CERTIFICATE OF APPROPRIATENESS

Property: 518 W. 12th Street, Tracts 34A, 35A, and 36A, Block 205, Houston Heights Subdivision. The property includes a historic 980 square foot, one-story wood frame single-family residence and a detached garage situated on a 4,400 square foot (44' x 100') interior lot.

Proposal: Alteration – Construct a rear 1 and 2-story addition to a contributing one-story residence

Recommendation: Approval with conditions: The foundation remains at 2'-3" and not be raised 8" to 2'-11".

EAST SIDE ELEVATION

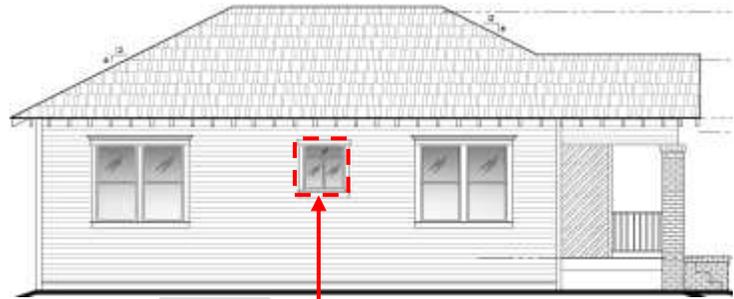
Non-original aluminum box window

Proposed 1-over-1 wood sash window

Side Elevation: Replace an existing non-original aluminum box window with a 1-over-1 wood sash window; the opening will not be modified.
(East)

WEST SIDE ELEVATION

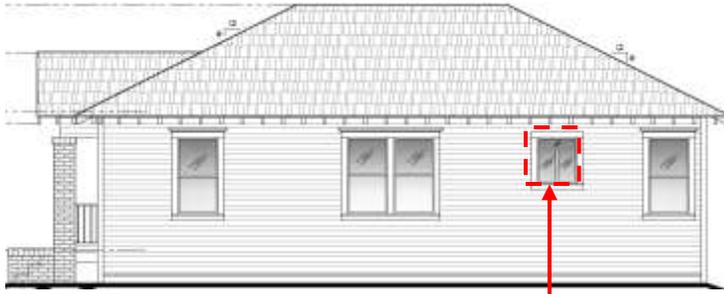
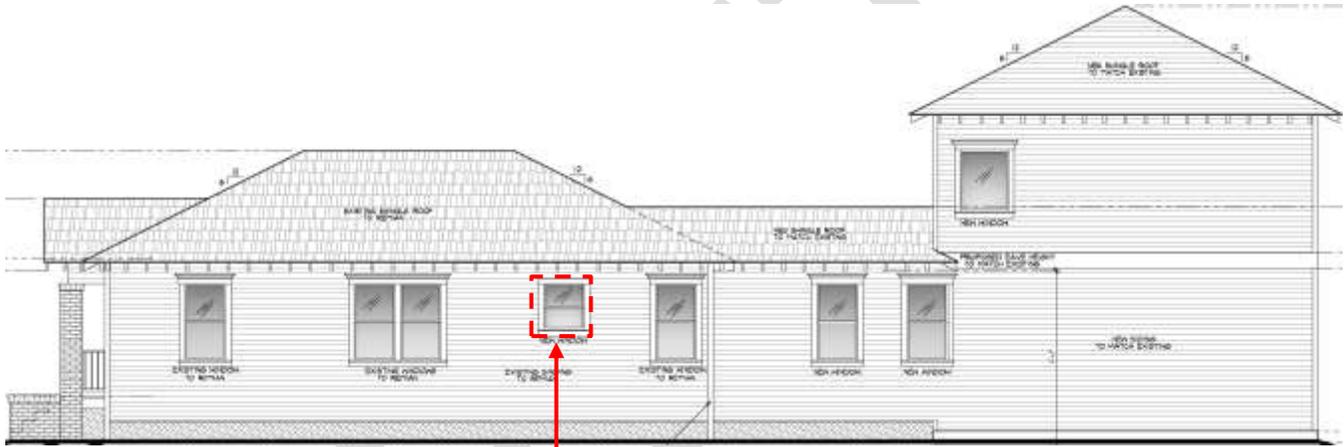
Non-original aluminum box window

Proposed 1-over-1 wood sash window

Side Elevation: Replace an existing non-original aluminum box window with a 1-over-1 wood sash window; the opening will not be modified.
(West)
